**Planning Commission Regular Meeting
City Council Chambers, 2660 Civic Center Drive
Draft Minutes – Wednesday, February 2, 2022 – 6:30 p.m.**

REQUEST FOR PLANNING COMMISSION ACTION

Item Description: Consider a request by Driven Brands, LLC (Take 5 Car Wash), for a Conditional Use to allow a drive-through at 1701 County Road C (PF21-020)

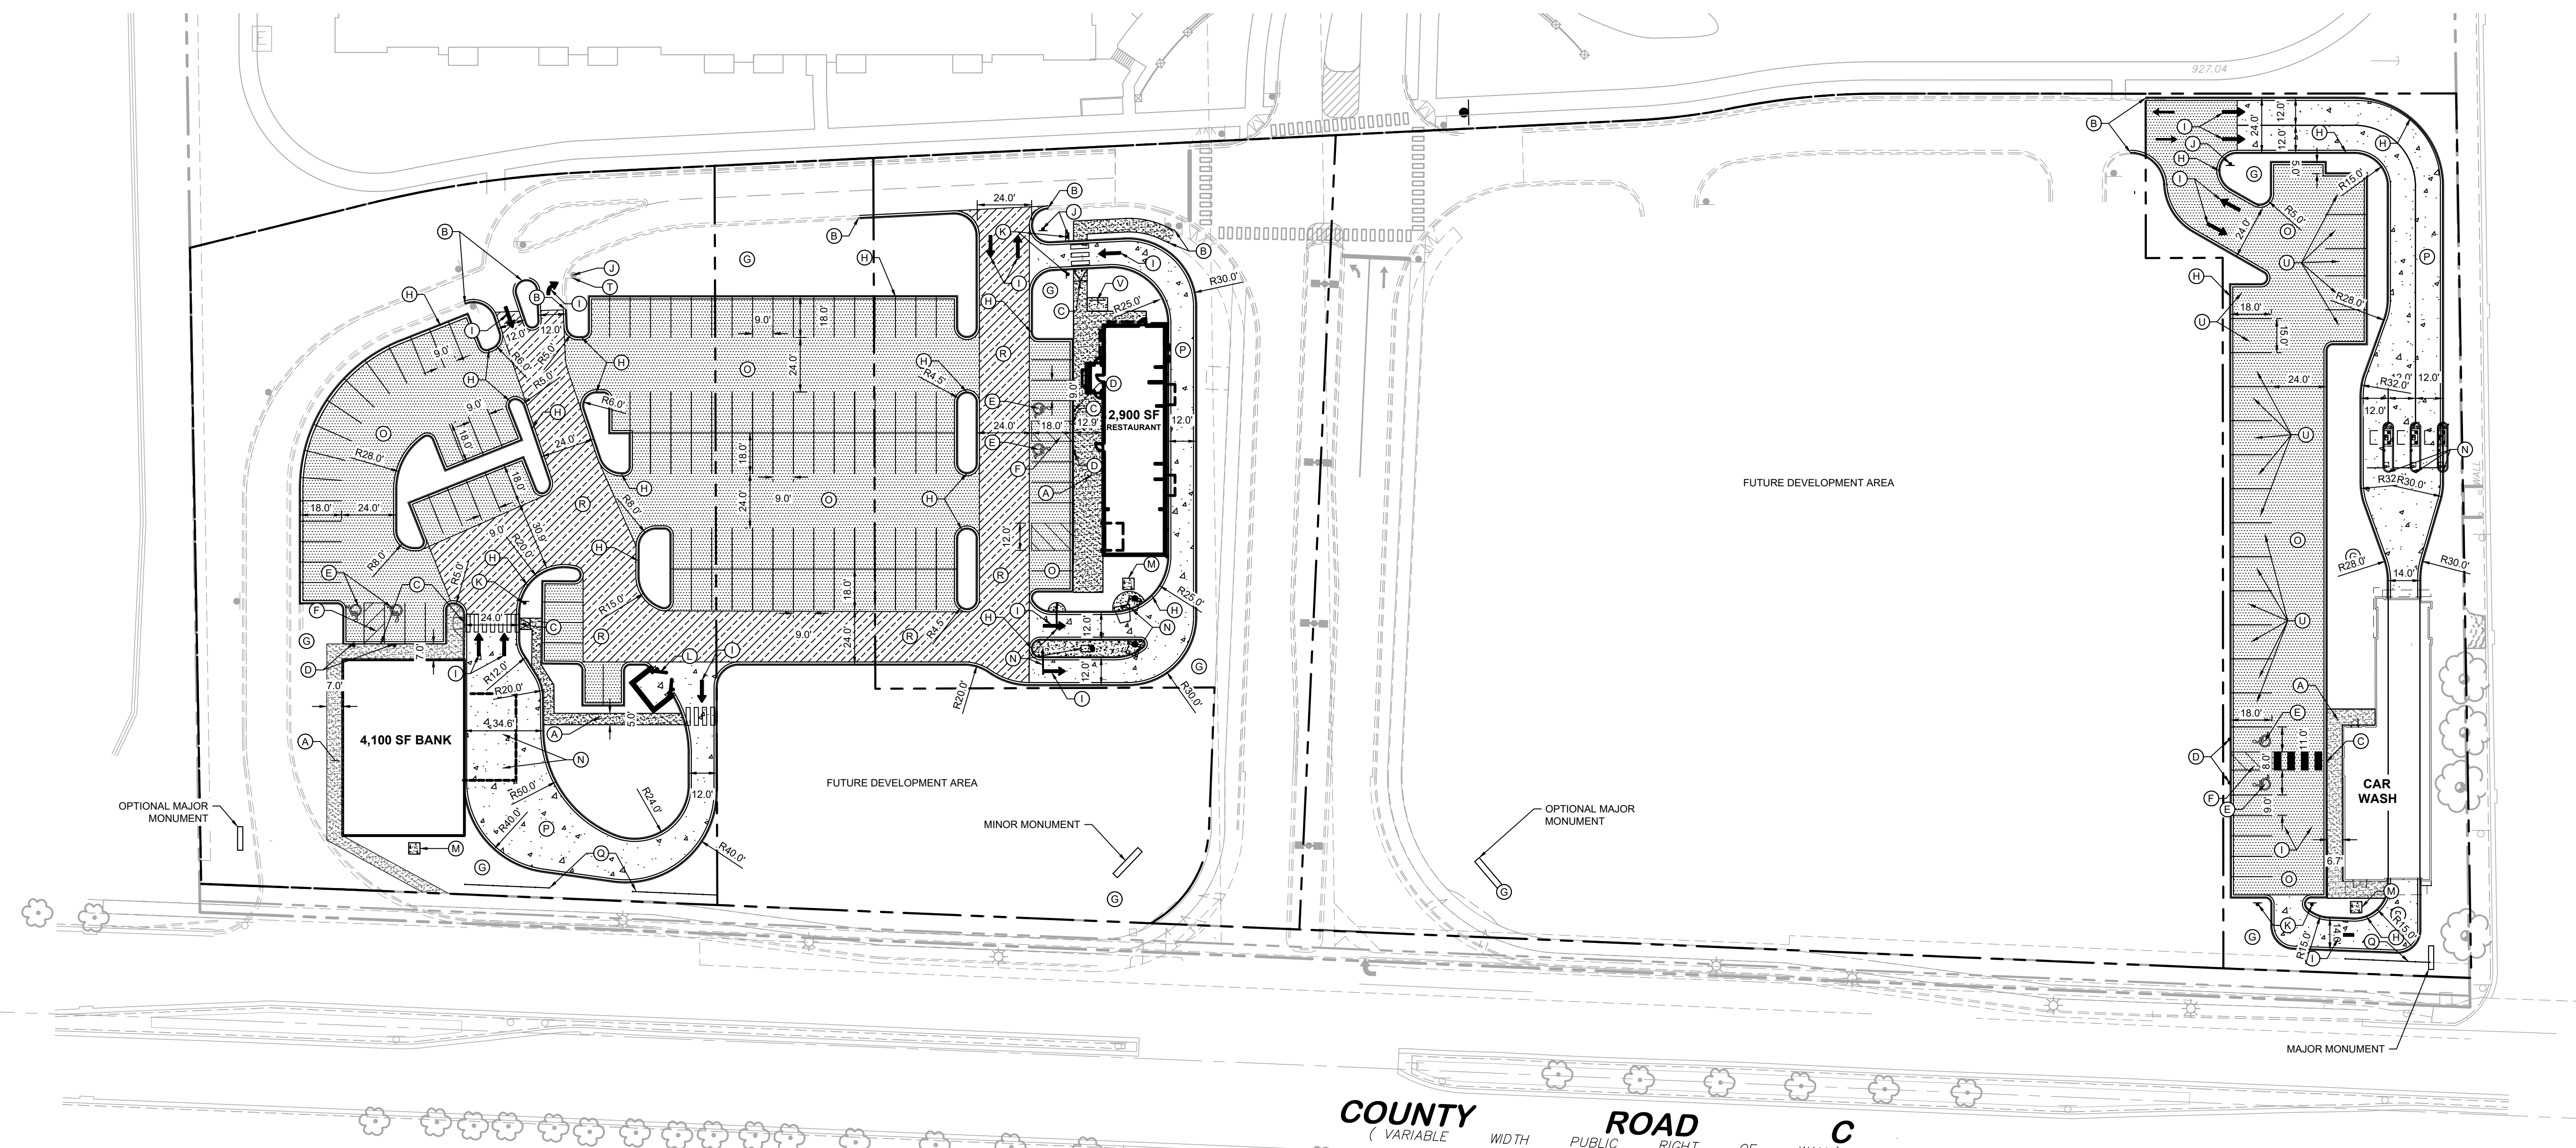
11. A site plan review was not completed at part of the study to identify any changes with the site plan.
12. The site plan shows the bank having approximately 290 feet of queueing space. A study by Spack Consulting, using empirical data, shows that the average maximum queue for banks is 6 vehicles (120 feet), and the 85th percentile queue is 8 vehicles (160 feet). The proposed driveway for the bank should provide sufficient space for queueing.

13. The site plan shows the car wash having approximately 480 feet of queueing space. A study by Spack Consulting, using empirical data, shows that the average maximum queue for car washes is 5 vehicles (100 feet), and the 85th percentile queue is 6 vehicles (120 feet). The proposed driveway for the car wash should provide sufficient space for queueing.

14. The site plan shows the restaurant having approximately 220 feet of queueing space. A study by Spack Consulting, using empirical data, shows that the average maximum queue for fast food restaurants is 8.5 vehicles (170 feet), and the 85th percentile queue is 12 vehicles (240 feet). The proposed driveway for the restaurant should provide sufficient space for queueing at most times, but at its absolute peaks, queues may spillover into the parking area.
